Table 33-18, Item 4

33.3.7.2 Input average power

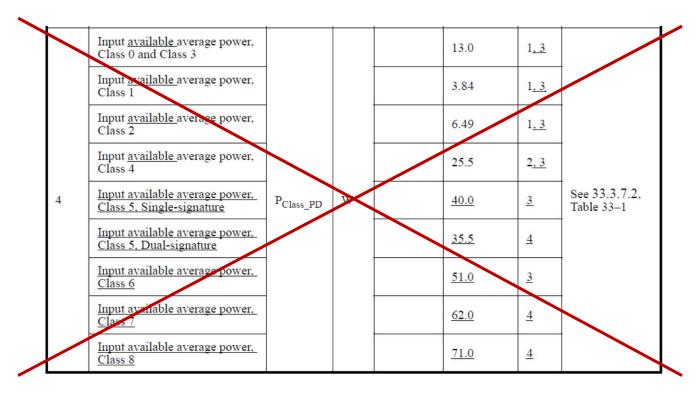
item	parameter	Symbol	Unit	Min	Max	PD Type	Additional information
•					•		
4	Input Average Power	Pport_PD	W		PClass_PD	1,2 3,4	See 33.3.7.2, Tables 33-16a, 33-1

(Note: Pport_PD is already defined as the average input power in 33.3.7.3)
